Shoalhaven Traffic Committee

Meeting Date: Tuesday, 12 December, 2017
Location: Jervis Bay Rooms, City Administrative Centre, Bridge Road, Nowra
Time: 9.30am

Agenda

TC17.93 - Attachment 1

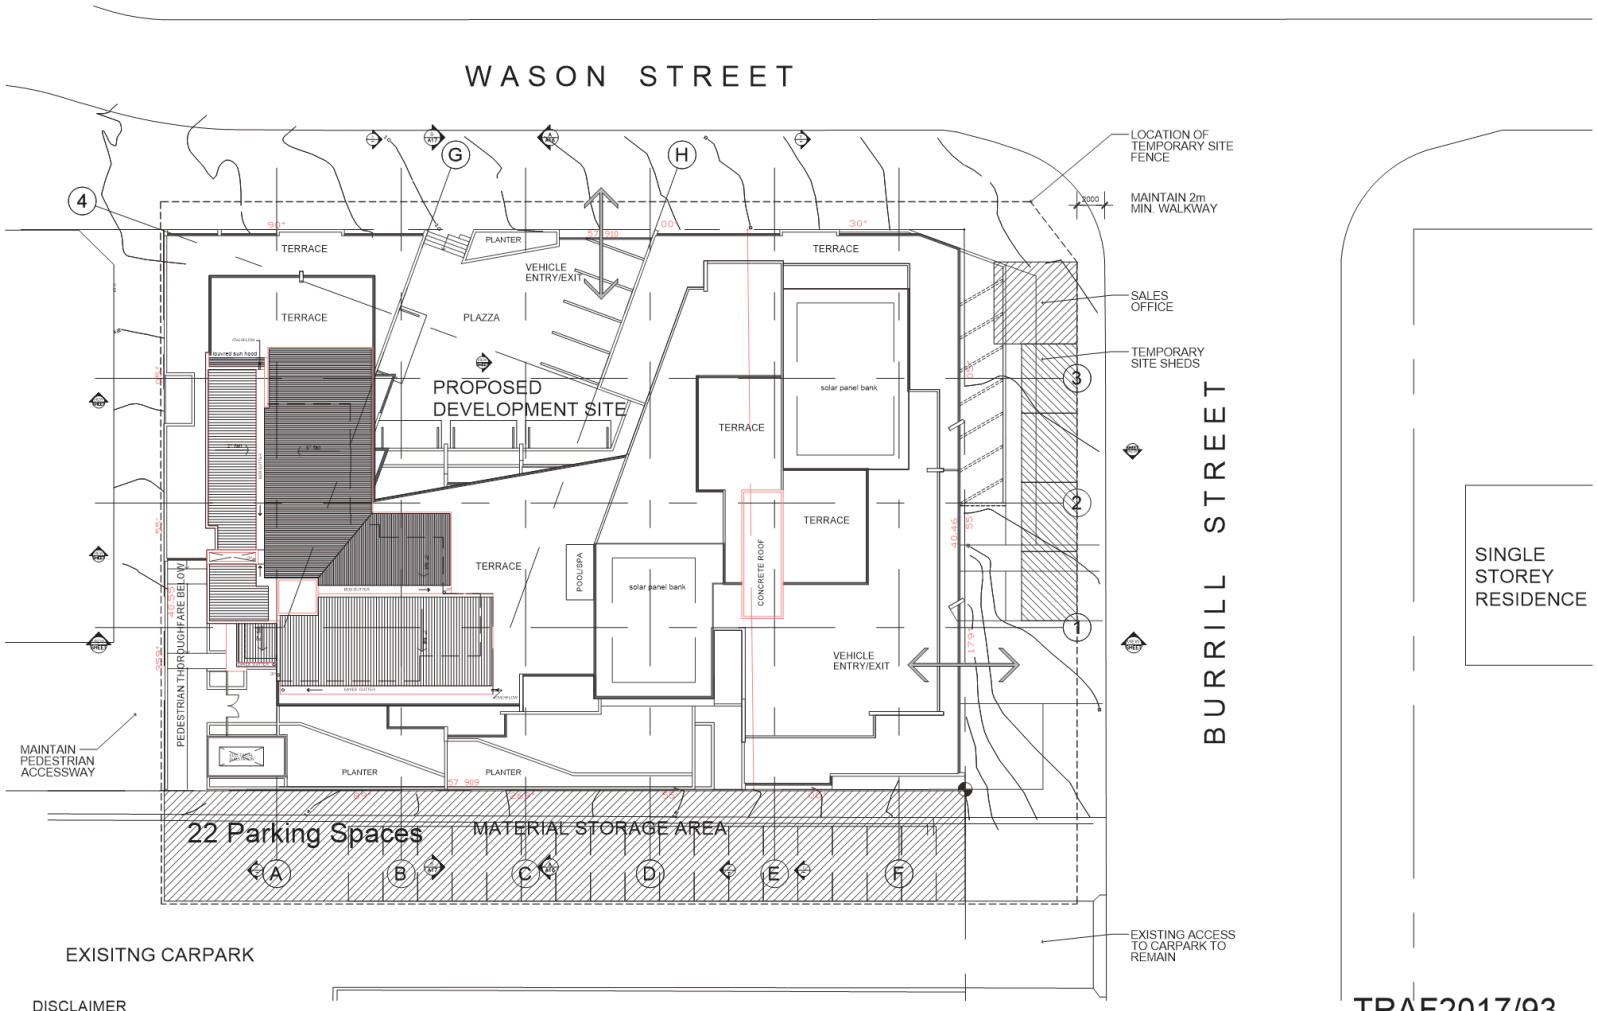
That the General Manager (Director Assets and Works) be advised that the Shoalhaven Traffic Committee has no objections of a technical nature to the temporary loss of 22 parking spaces in the off-street public car park of South Street during the 12 month construction phase as required by DA06/2236 and CC17/2407 at #26 - #32 Wason Street, Ulladulla as detailed in the attached plan TRAF 2017/93, subject to broader public consultation, the payment of associated fees and Section 138 approval.
